PIMA COUNTY

ADDENDUM NO. 5

SOLICITATION NO. 202583 – SUNSET ROAD: SILVERBELL ROAD TO INTERSTATE 10

This Addendum addresses question raised from January 12th, thru January 13th, 5:00 pm. This Addendum shall be incorporated and made part of the Bid Documents as though included therein. **This addendum is 22 pages.**

Scale:	As Noted	Sheet S23 of S43	Page 92 of 203

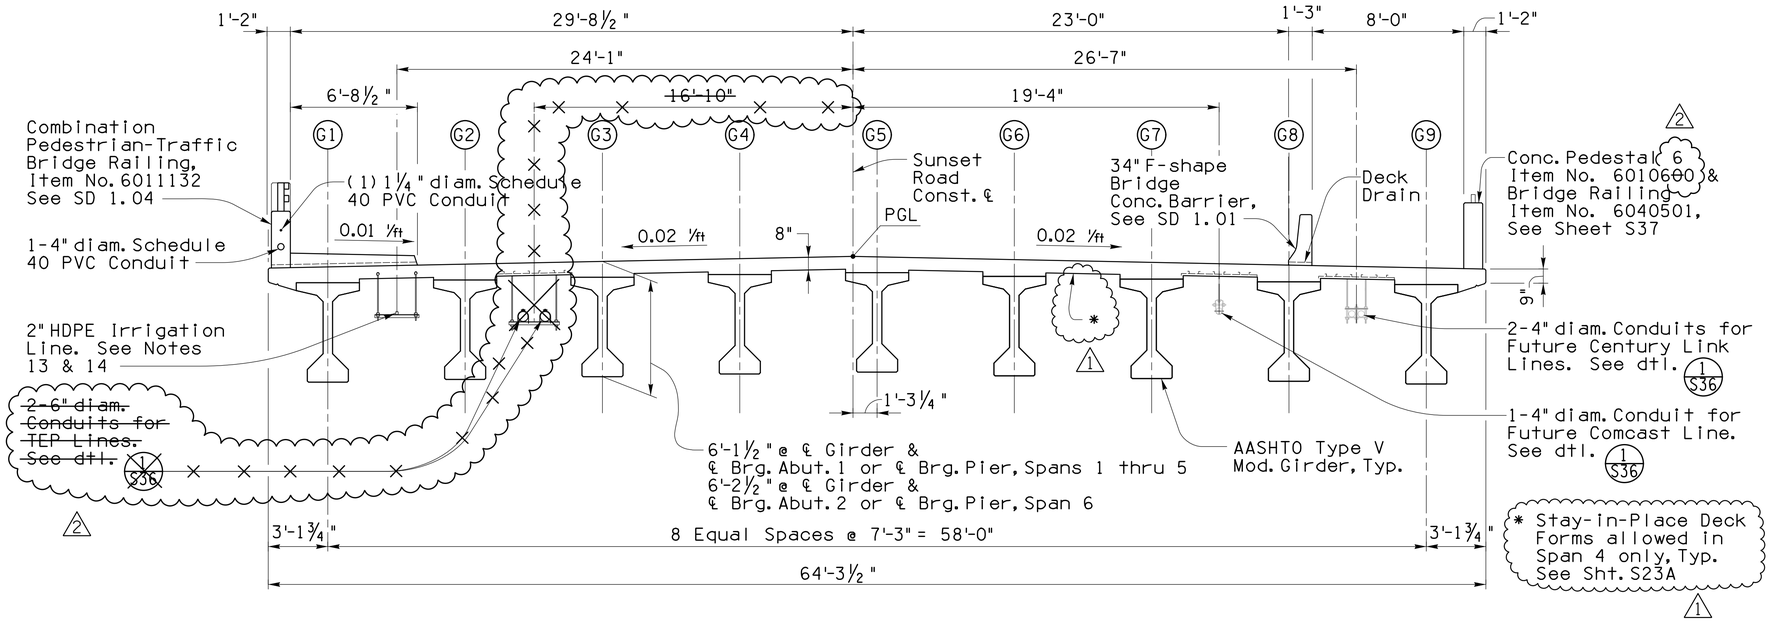
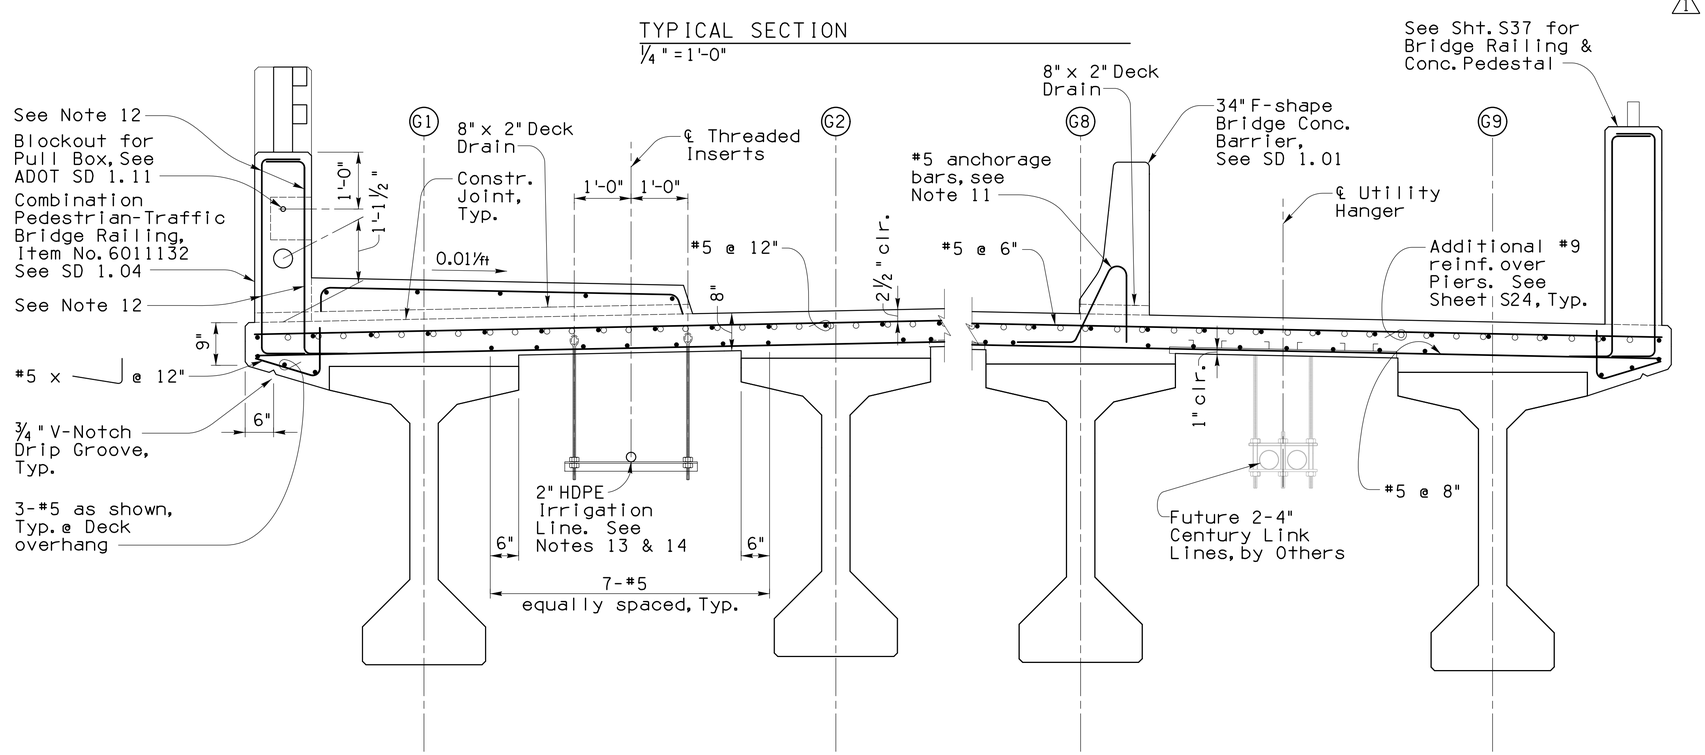
Q) Contractor cannot find bid item or information for 4" ITS across bridge and supports.
A) 4" ITS across bridge is in Combination Pedestrian-Traffic Bridge Railing. See Sheet S23-Page 92. Attachment 2 (1 page)

16. ITS and irrigation elec. conduits are incidental to cost of Combination Pedestrian/Traffic Bridge Railing.

UNISTRUT LOCATIONS - PARTIAL PLAN VIEW

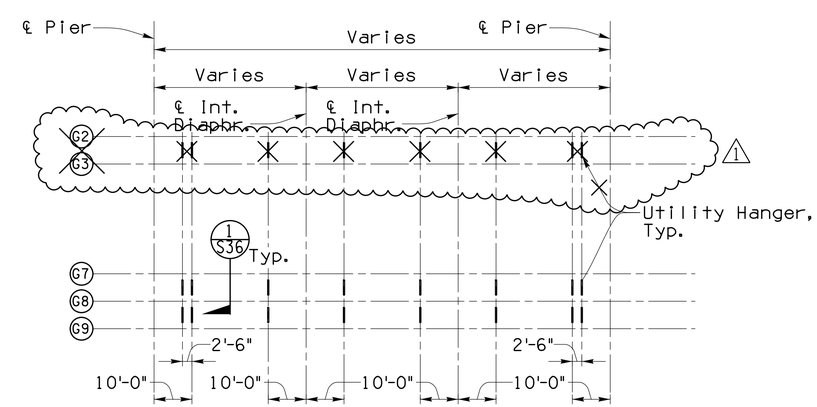
Notes:
1. Utility Hanger located typically per span between girder lines G9, G8, G7 ~~and G2, G3.~~
2. Coordinate Utility Hanger placement with deck reinforcing.

UTILITY HANGER DETAIL (1/S23) (1/S25)
3/4" = 1'-0"

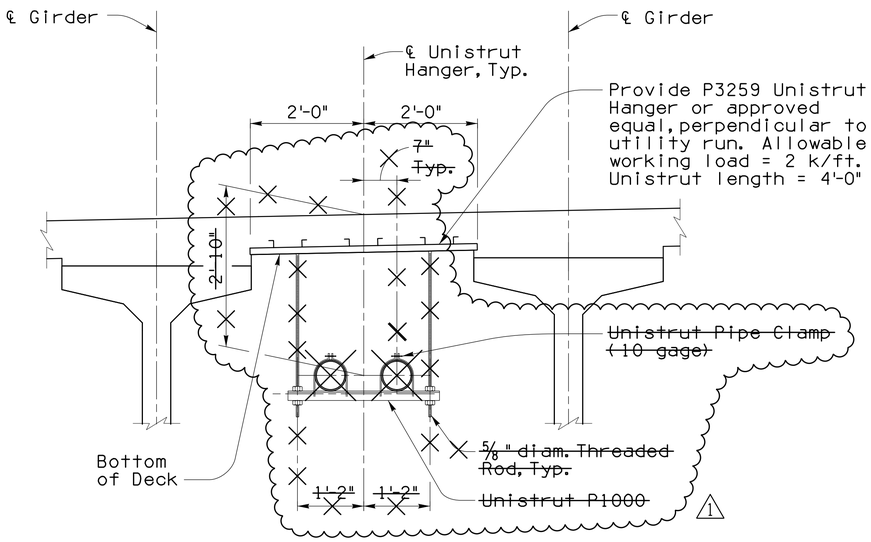
~~5. Utility Hanger for TEP consists of Unistrut P1000, pipe clamps, threaded rods and ancillary hardware. Hanger to be placed between girders G2 & G3. Bid Item No. 9230080.~~ 1

Scale:	As Noted	Sheet S02 of S43	Page 71 of 203

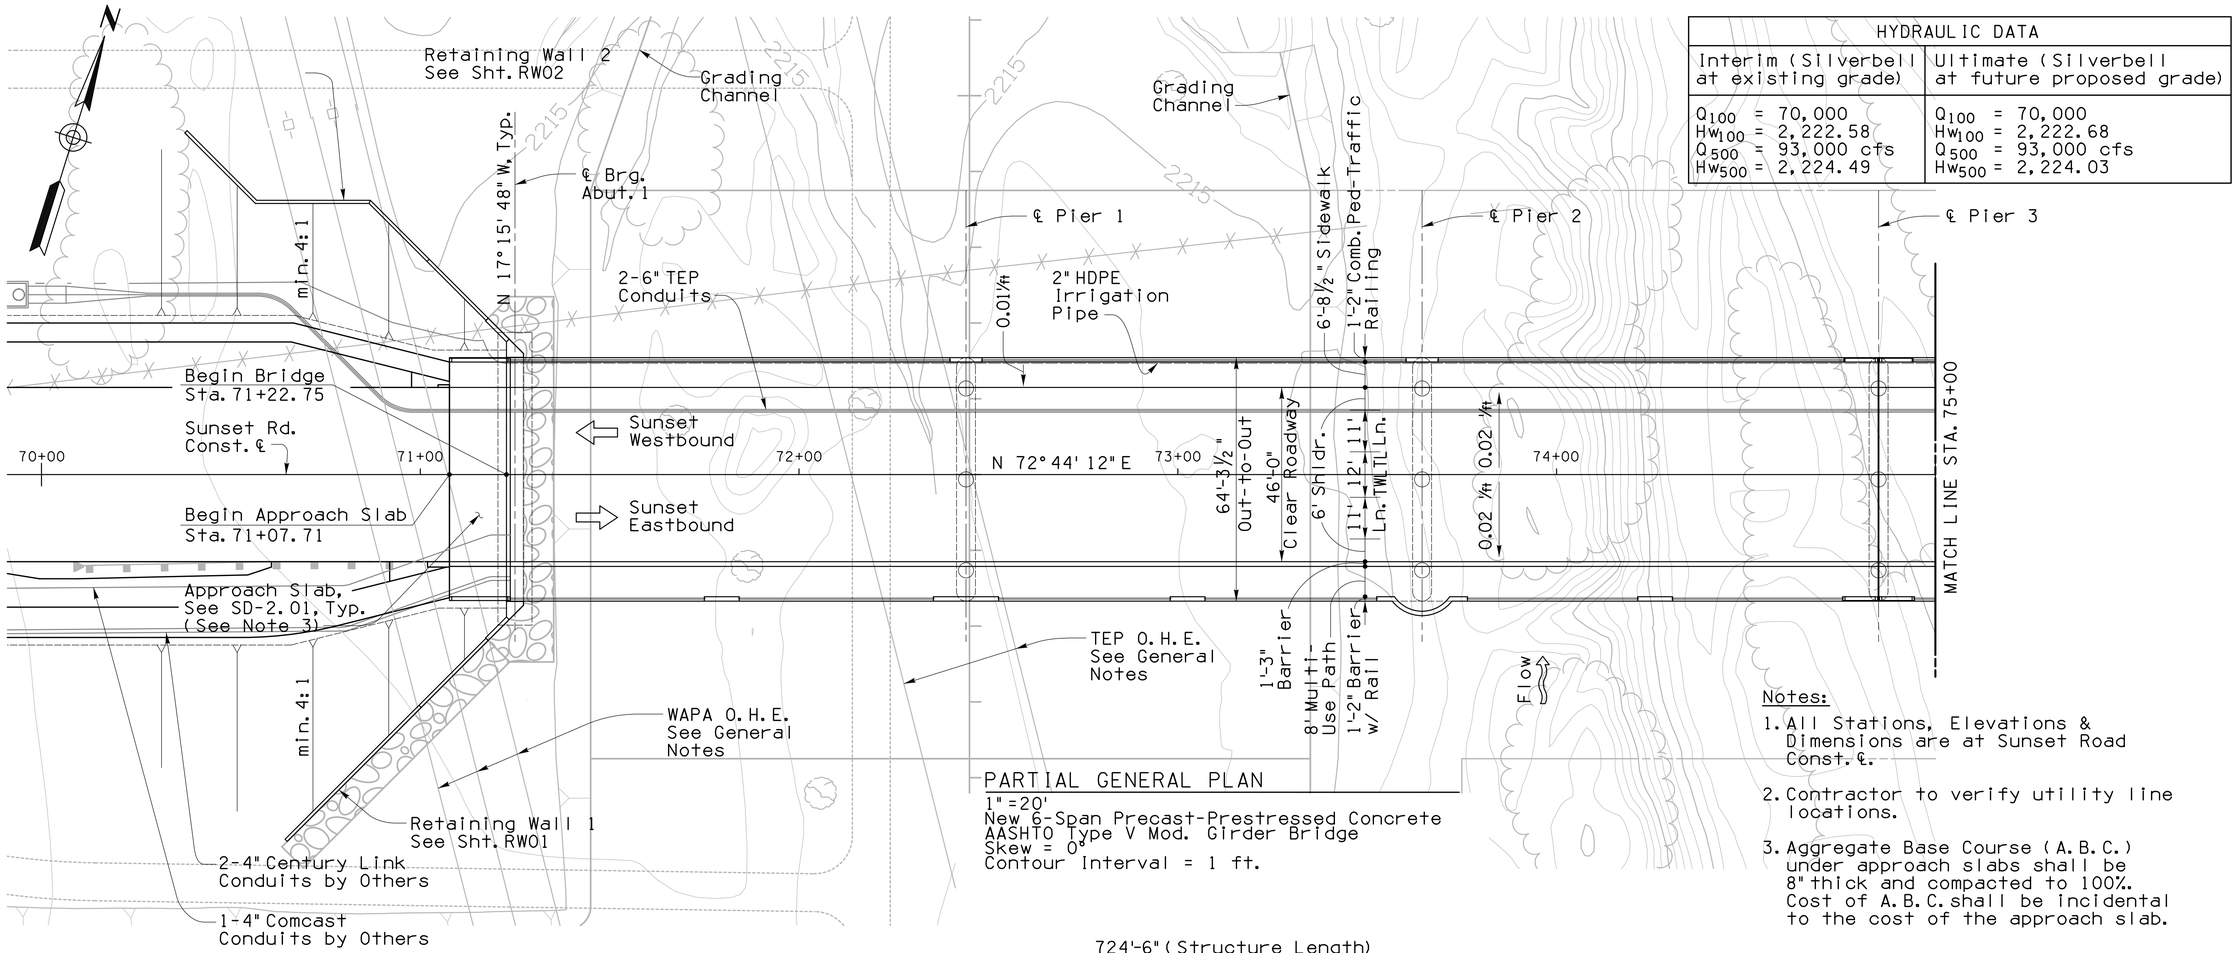
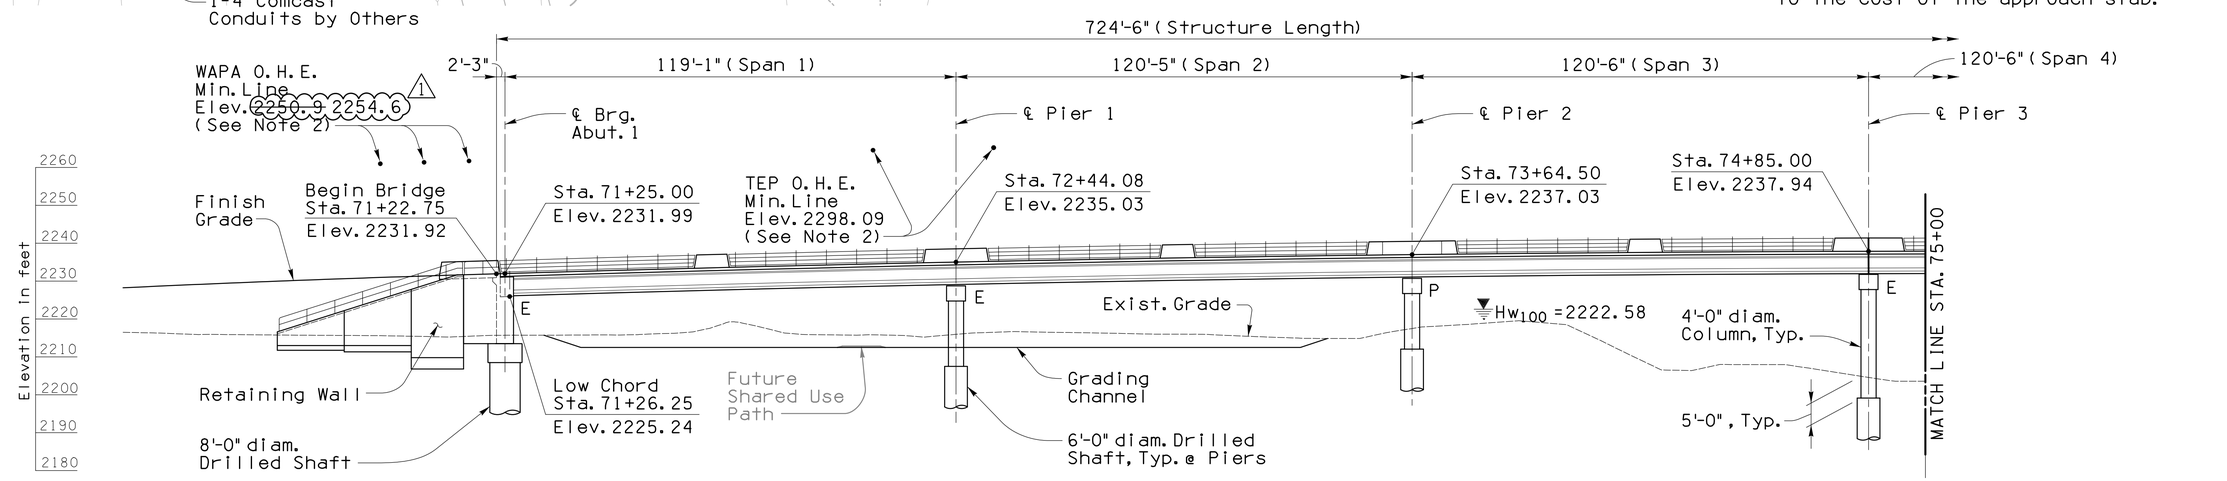
Q) The plans that we have on sheet 71 of 203, S02, show the WAPA lines at an elevation of 2250.9'. Please confirm that the actual is the 2255.1 as listed in addendum #4.

A) Elevations shown on Sheet PP02_Page 29 are as surveyed on August 17, 2015. Lowest line surveyed is 2254.6. Sheet S07_Page 71 has been revised accordingly. Attachment 3 (1 page)

Scale: As Noted | Sheet S06 of S43 | Page 75 of 203

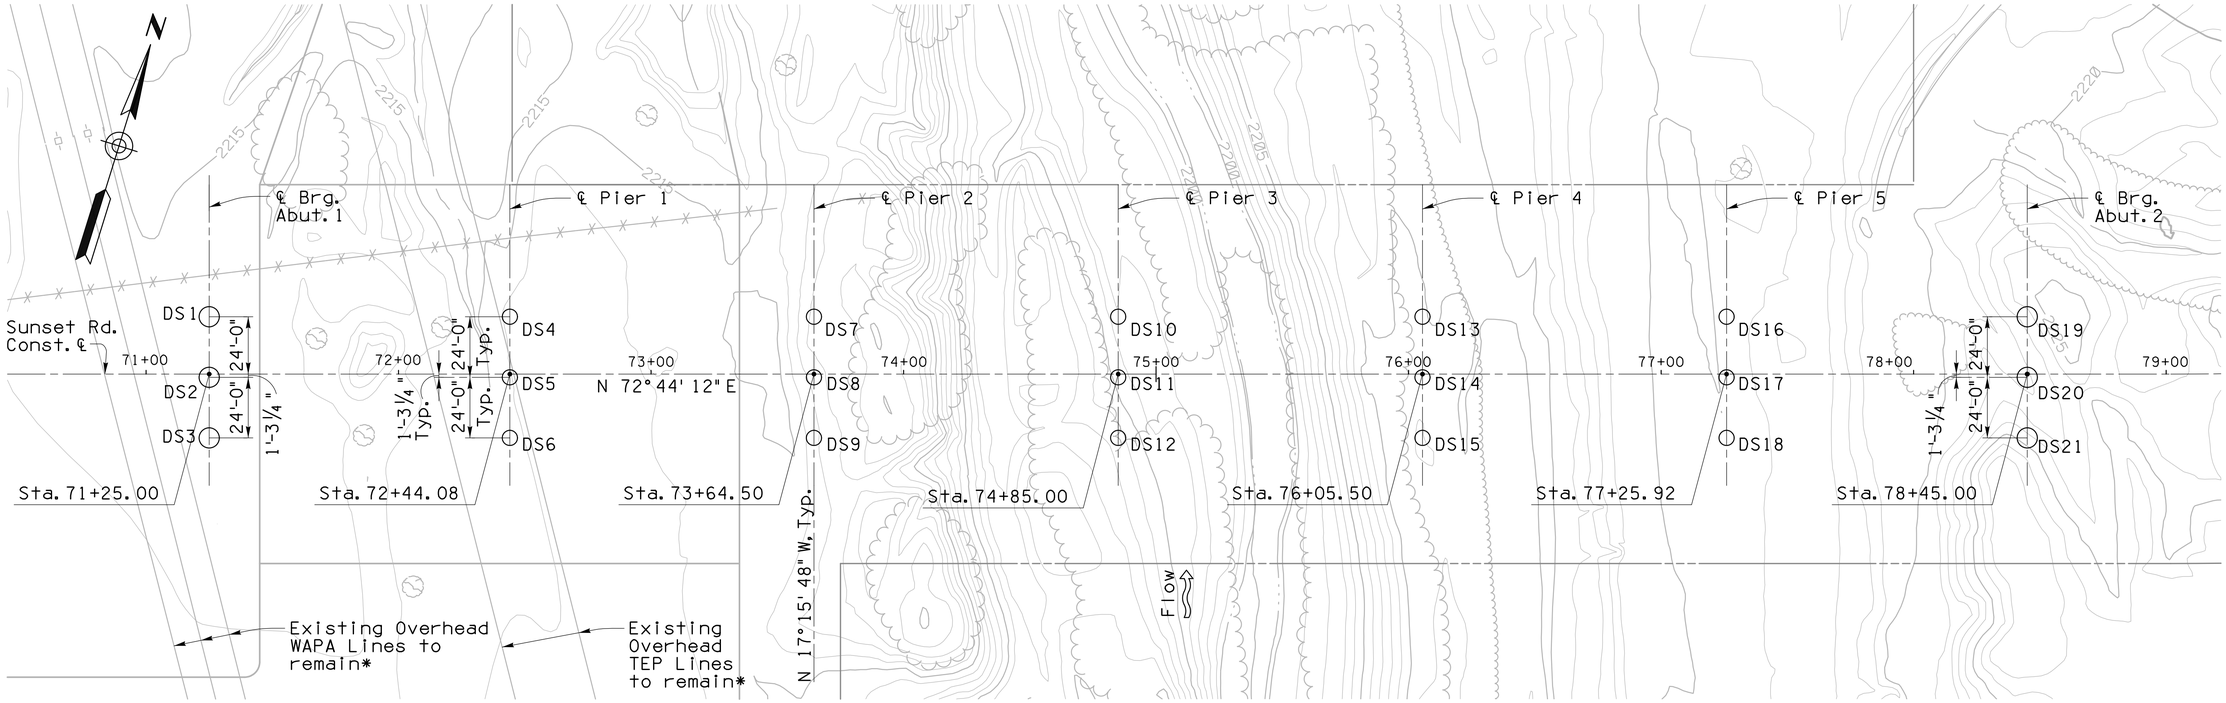
Q) Drilled shafts 1, 2 and 3 show a total length of 131.75' each. However, when the tip elevation and top elevation are subtracted there length is 116.75'. Please advise.

A) The length shown on the plans should be as stated, 116.75'. Attachment 4 (1 page)

Scale: 1"=40' Horiz. | Sheet CD05 of CD06 | Page 49 of 203

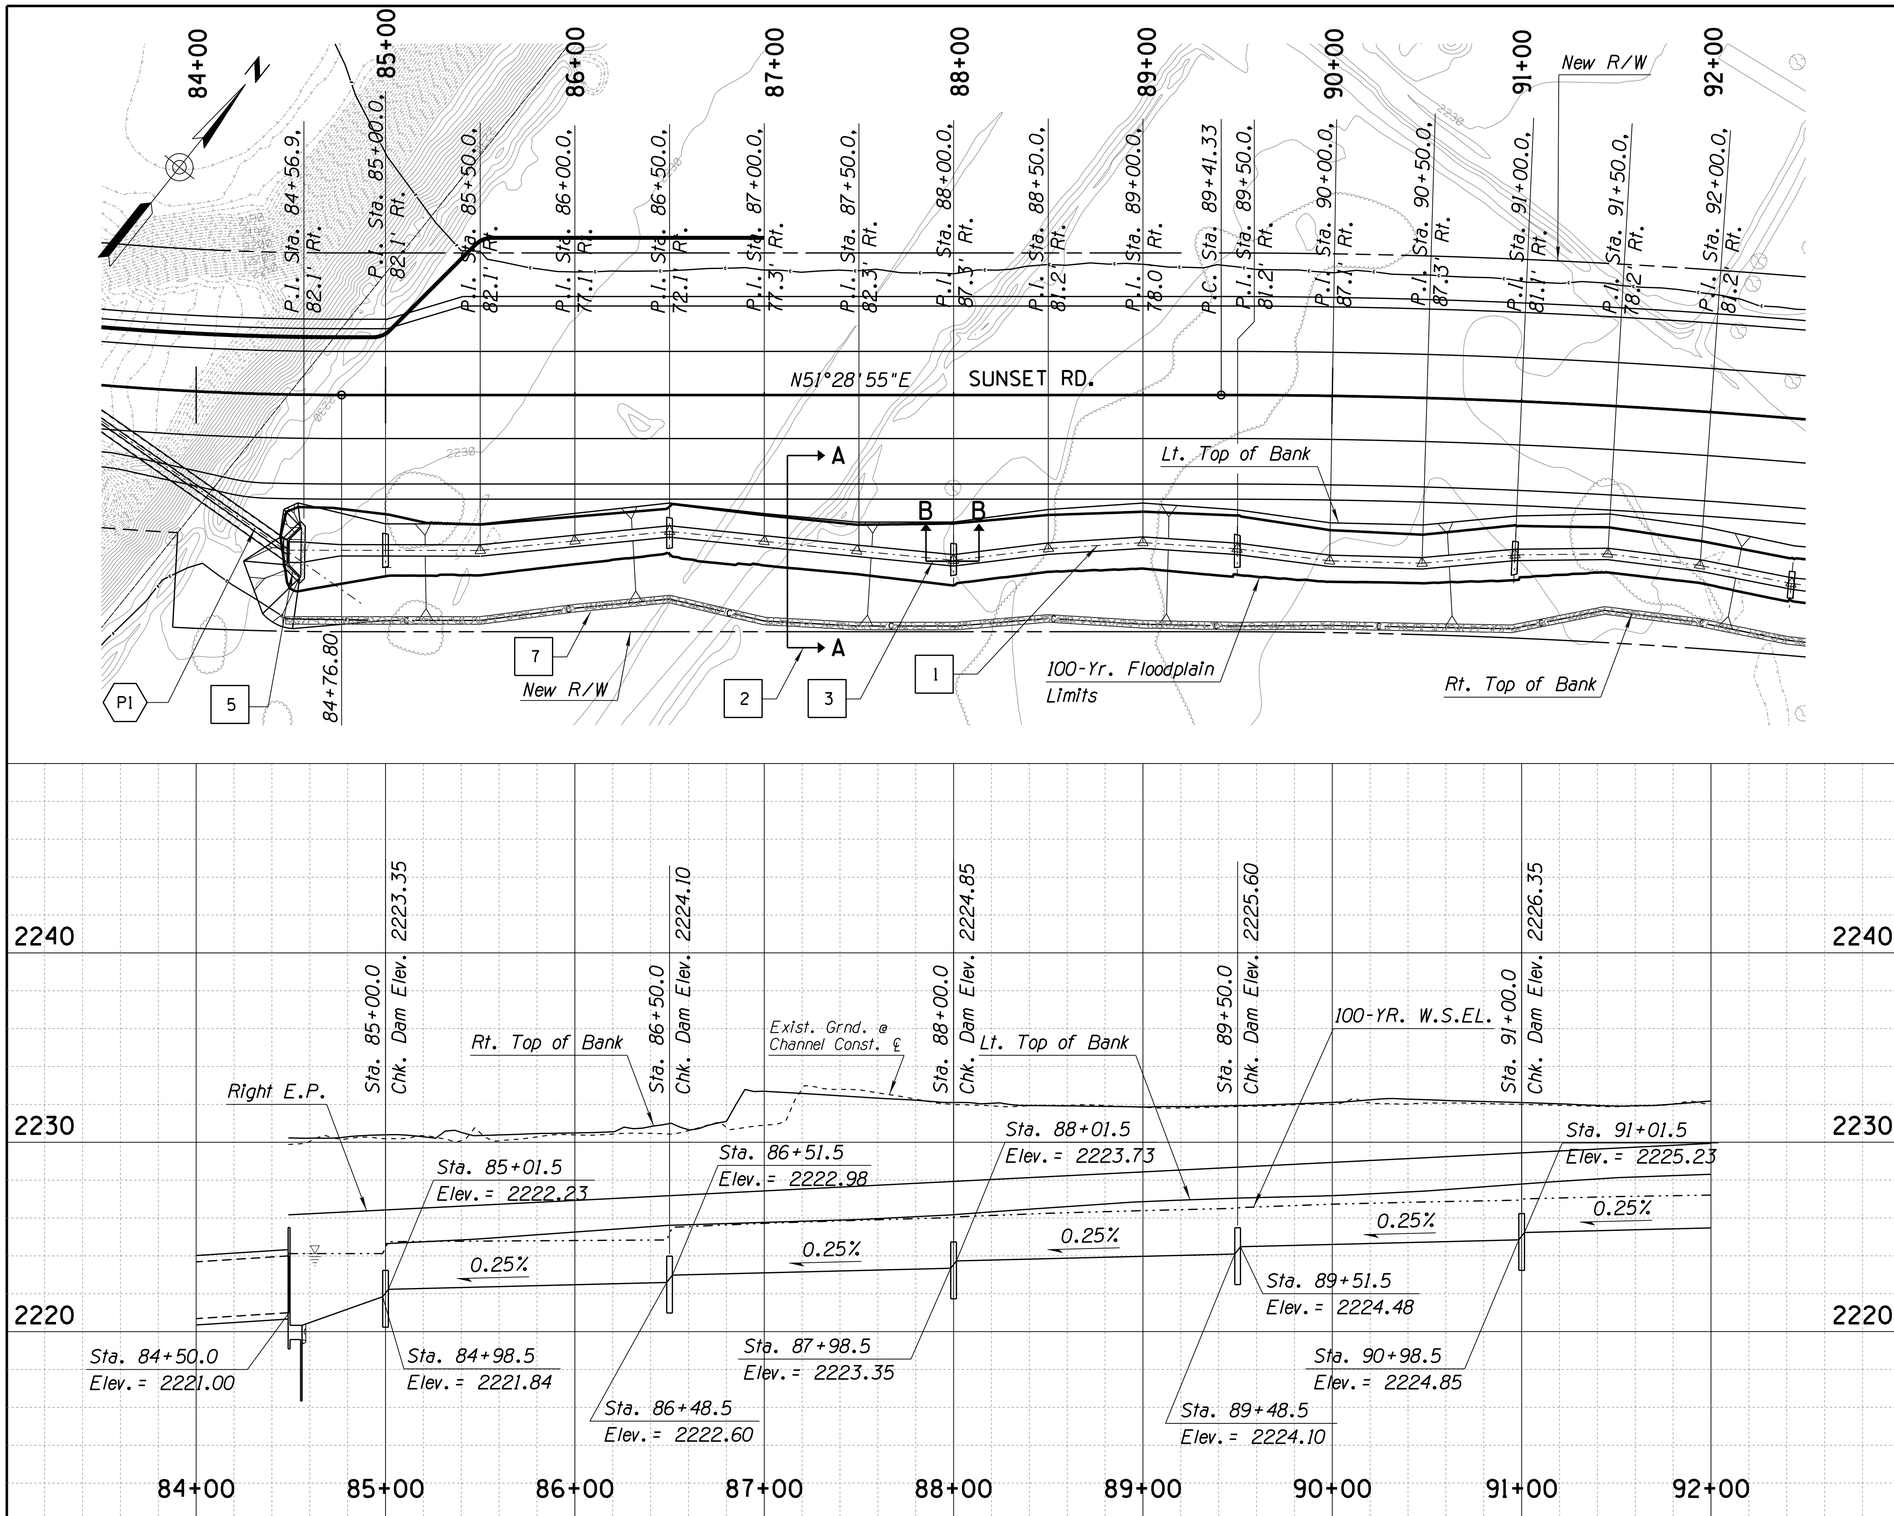
Q) Plan Sheet 20 shows Gabion Baskets (Bid Item 9130005) with a staking table giving dimensions of the slopes and a bottom that varies. Gabions Baskets come in lengths such as 3', 6', and 9' and do not fit the staking table for the slopes or the bottom of channel or the lengths given in the Gabion Check Dam Table. If the dimensions given are to be considered a minimum will the pay item include full payment for the CY of Gabions installed?
A) The "Staking Table" relates to the grading of the channel between gabion check dams. The "Gabion Check Dam Table" on the same Sheet RD12_Page20 show the gabion lengths, thickness and quantities that are in 3' increments. Please see Attachment 5 (2 pages)
